ADDENDUM NO. 2

PROJECT: Reservation Road Desalination Plant Renovation Project, Phase 1

CIP NO.: GW-2404GN

ISSUED: December 18, 2025

**T-TRENCH AND RESTORATION DETAIL
ASPHALT CONCRETE STREETS**

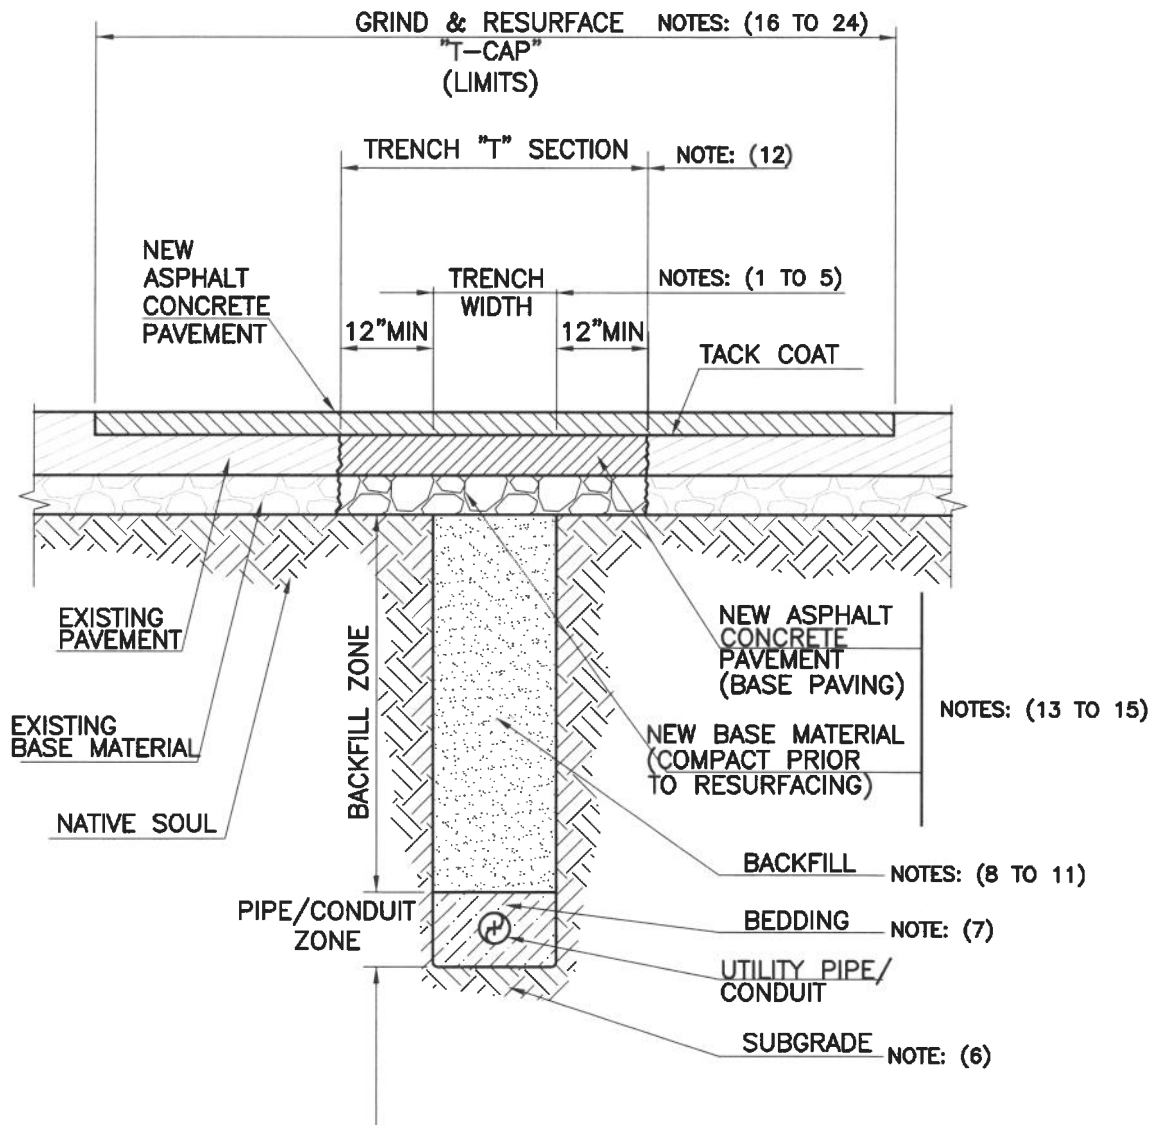
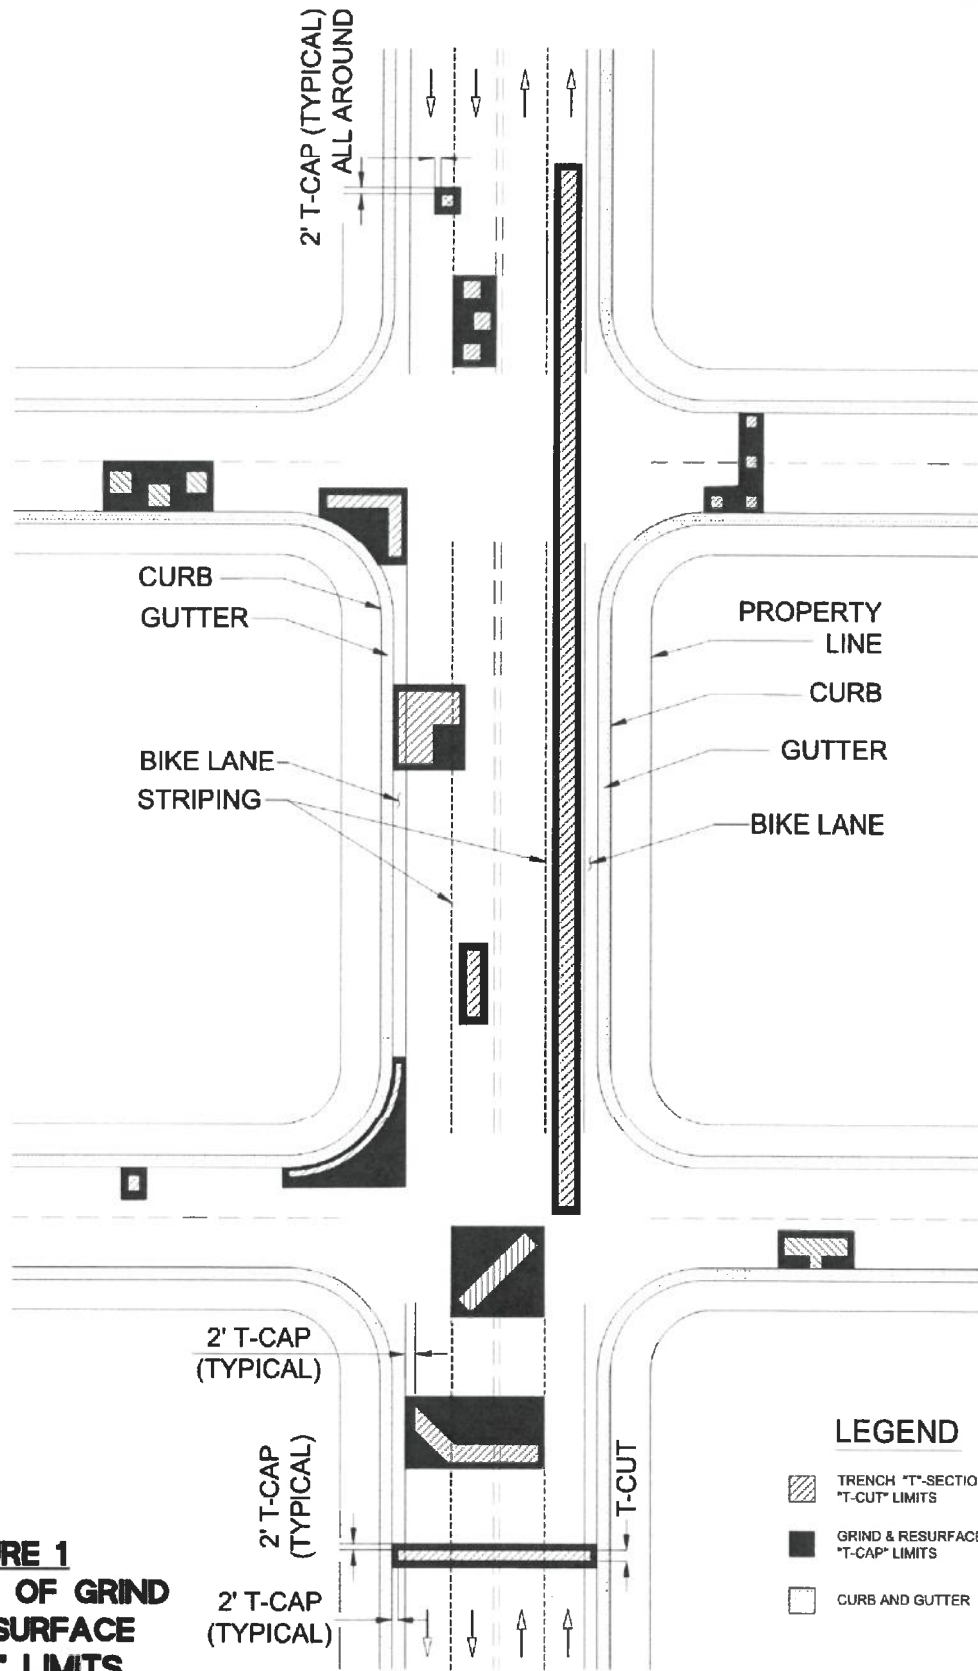
- A. Replace City of Marina Standard Detail ST-25 on Sheet C-4.0 with City of Marina Standard Detail SD-1. Refer to Exhibit B for City of Marina SD-1.

Q1 *Note 2 under the City of Marina's trench backfill detail (ST-25) states "the structural section must match the existing structural section of the roadway. AC, AB, ASB and any other existing compound." However, the plans and specifications do not indicate the existing thicknesses of the AC or AB layers. Please provide the existing AC and AB thickness.*

A1 For Bid Item #8 and Alternative Bid Item #1: AC Layer Thickness: 7"
AB Layer Thickness: 8"

For Bid Item #11 and Alternative Bid Item #2: AC Layer Thickness: 3"
AB Layer Thickness: 5"

Note that ST-25 has been replaced in its entirety by City of Marina detail SD-1, attached herein as Exhibit B.
